Office Action Summary

10/517,196

ROMMEL, CHRISTIAN

DETAILED ACTION

Fig. 1.

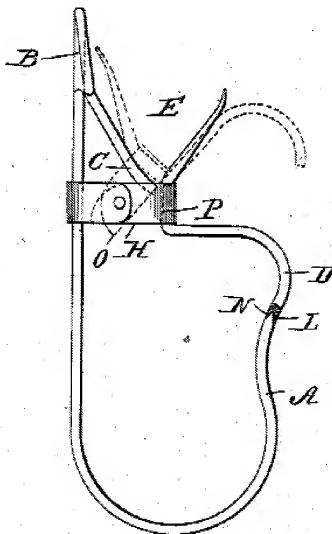
Claims 1-3 and 5-8 are rejected under 35 U.S.C. 102(b) as being clearly anticipated by Keep (US 535622).

Keep (figure 1) teaches a holder inherently capable of holding sample cards having eyelets therein comprising two holding bodies, A, D, forming a ring-like configuration, two handgrips, B, E, with one, B, having an eye fully capable of being a hanging device for the holder, a spring, C, loaded pivoted joint, H, and beveled end faces, N, L, on the holding bodies.

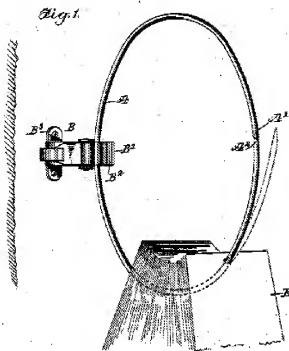
The difference is that the holding bodies don't form an oval. However, Stebbings (figure 1) provides ample evidence that it is old and well known to form an oval holder (page 1, lines 70-74).

Therefore, it would have been obvious for the holding bodies of the devices of either Crandell or Keep to form an oval in view of Stebbings (figure 1) teaching that it is old and well known to form an oval holder (page 1, lines 70-74).

own resiliency to receive the file loop, 70
The file-loop A, as shown in the drawings, 70
is preferably made oval and adapted to open,
one end A' being in the form of a socket
adapted to receive the point A' formed on
the other end of the file loop. When the
point A' is disengaged from the socket A', 75
